SECTION 4.55(1A) MODIFICATION APPLICATION - SSD 8903
Stage 1 of Ivanhoe Estate (Midtown), Macquarie Park

This application has been prepared by Ethos Urban on behalf of Frasers Property Australia pursuant to section 4.55(1A) of the *Environmental Planning and Assessment Act 1979* (EP&A Act) to modify SSD-8903 relating to the Ivanhoe Estate (the site).

Figure 1 Approved car park exhaust and lift location

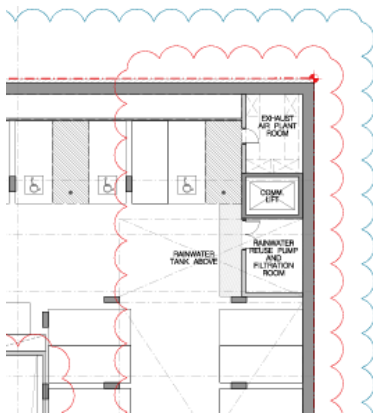
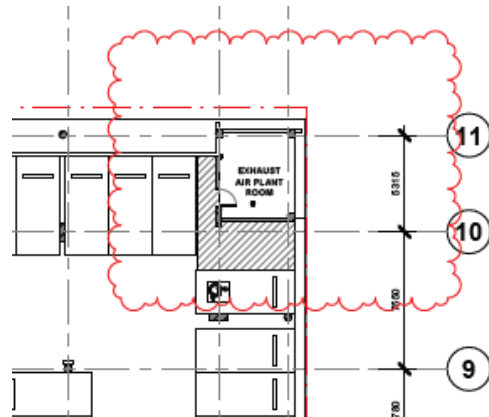
The modifications to Building C1 include the relocation of the car park exhaust and lift into the C2 building footprint area and the provision of openings from the C2 lower ground floor plan to the car parking area which is provided as part of the C1 building footprint, but services the C2 gymnasium, pool and community facilities. The amendments including the deletion of the lift and change in arrangement of the exhaust plant on Basement 3 are demonstrated at **Figures 1** and **2** below. The provision of openings to the C2 building on Basement 3 are demonstrated at **Figures 3** and **4** and the stage 2 C2 plans currently under assessment by the Department are provided at **Figure 5**. Note that amendments surrounding the exhaust are also proposed up to the ground floor plan.

Figure 7 Proposed Unit layout plan (Unit C.14 – 1.01)

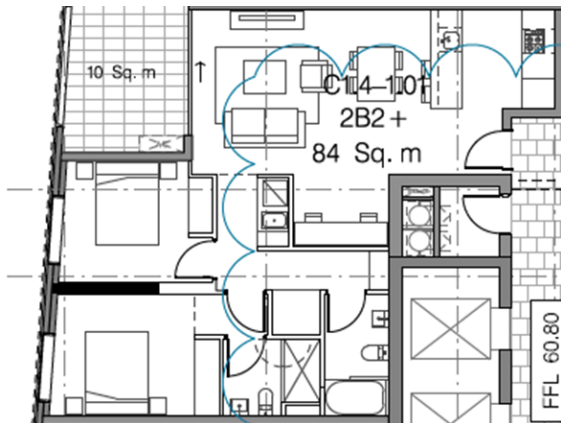
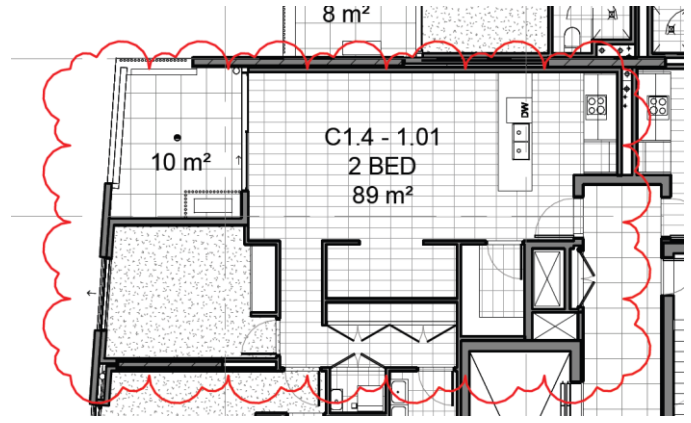
Firstly, it is proposed that the layout of Unit 4 on Upper Ground to Level 12 is to amended to provide the waste chutes in a cupboard arrangement rather than a separate room which results in the creation of extra space at what would have been the rear of the cupboard. This amendment then allows for the provision of an additional storage cupboard to each unit in what was the area of the chutes. **Figure 6** and **7** demonstrate the proposed residential change.

Figure 9 Proposed unit layout plan (Unit C.1 - B1.02)

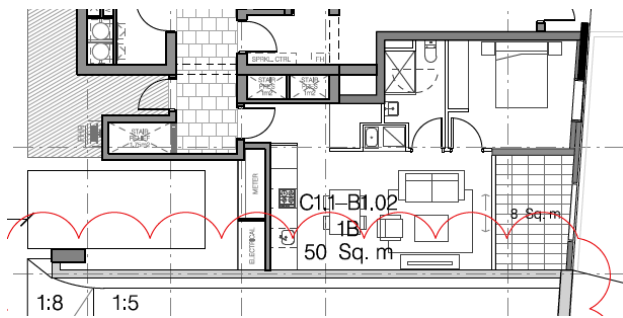
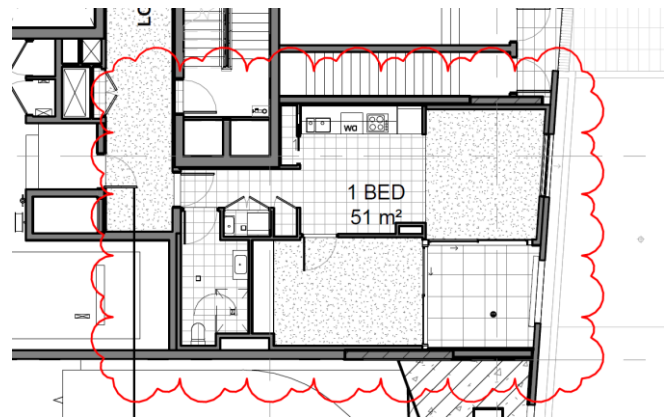
Secondly, Unit B1.01 layout design is proposed to be amended as a result of design development for better use of space within the apartment. Layout changes have resulted in the bathroom, bedroom, living, dining & kitchen to be relocated for the better use of space and access to open area.

Figure 11 Proposed unit layout plan (Unit C.1.1-LG.02)

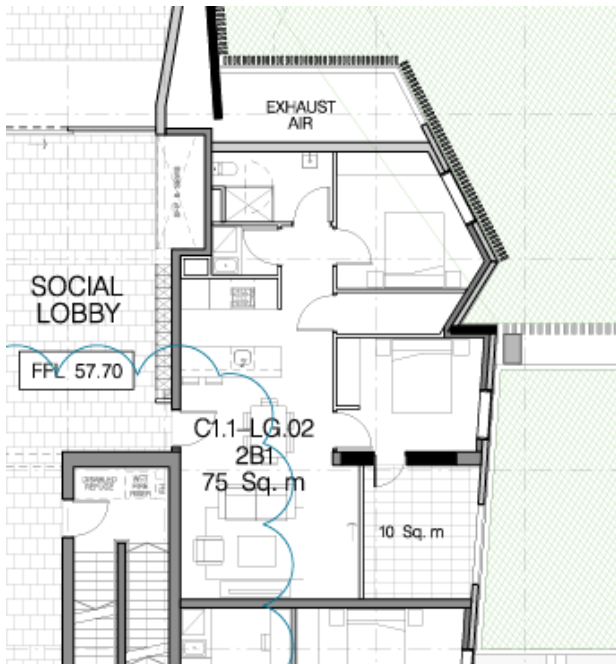
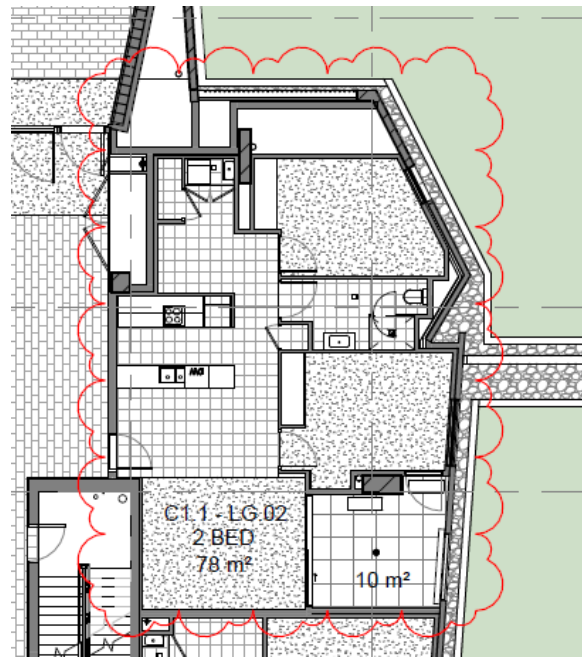
Thirdly, Unit LG.02 in Building C1 is proposed to be amended to provide additional storage opportunities and due to the change of size of the exhaust plenum. The amendment to the layout of the unit is demonstrated at **Figure 10** and **11**.

Figure 5 Approved cold shell of Community room

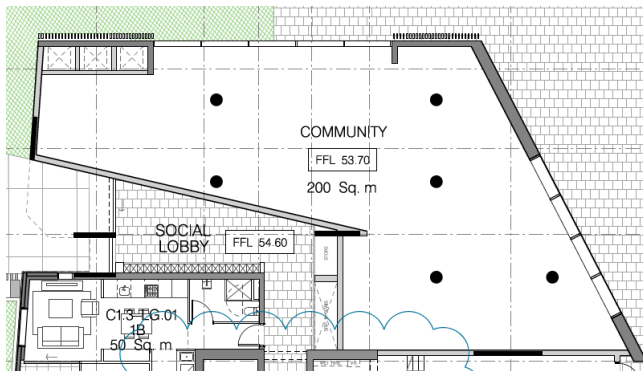
The proposed modification seeks to fit out the community room in Building C1. As approved the community room was approved as a cold shell, this modification proposes to fit out the community room to include a kitchen, office space, meeting rooms, an accessible bathroom and a flexible space.

Figure 8 Proposed B1 layout

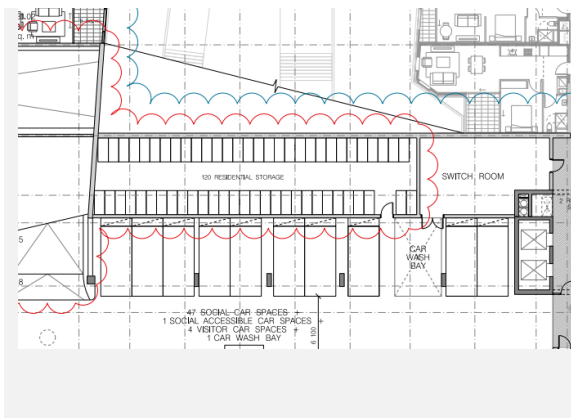
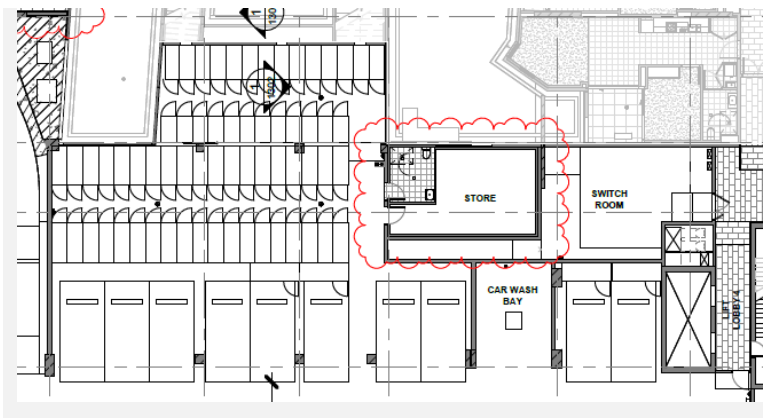
The modification seeks to amend the design of Basement 1 to amend the layout of the storage area to stretch beneath the terraces and stair zone and introduce a separate storeroom and bathroom in this space.

Figure 10 Proposed C1.4 Terrace

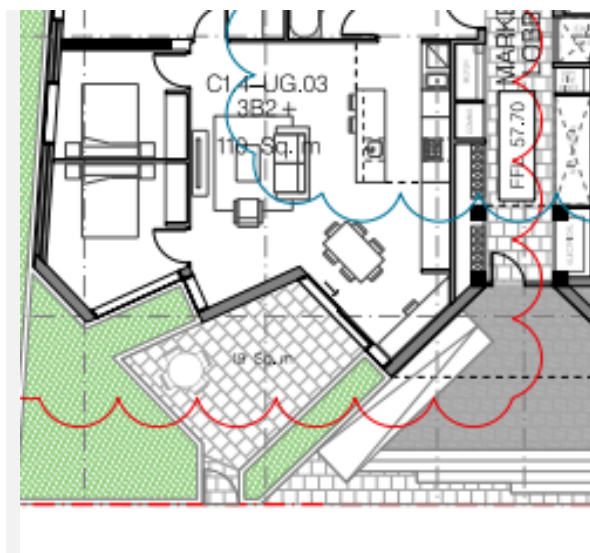
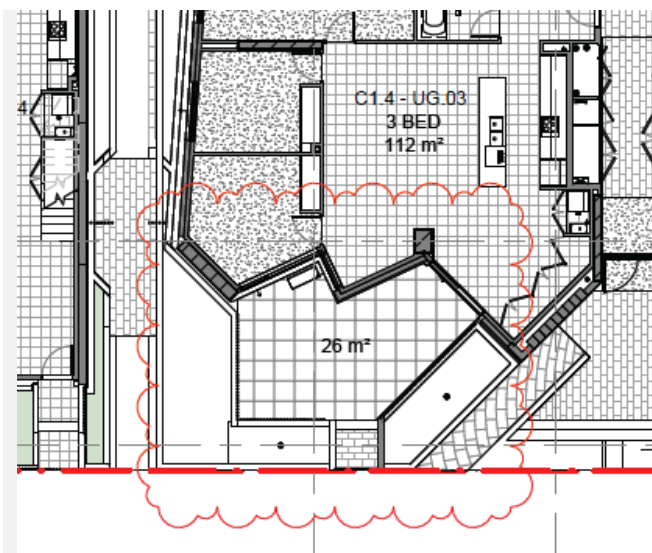
The modification includes slight adjustments to the design of the C1.4 terrace area as demonstrated at **Figure 9** and **Figure 10** below. The modification results in an increase in the area of the terrace from 19m² as approved to 26m². In addition to being slightly larger, the proposed design provides a more regular shaped area and allows the bedroom to open to the terrace area rather than a small garden.
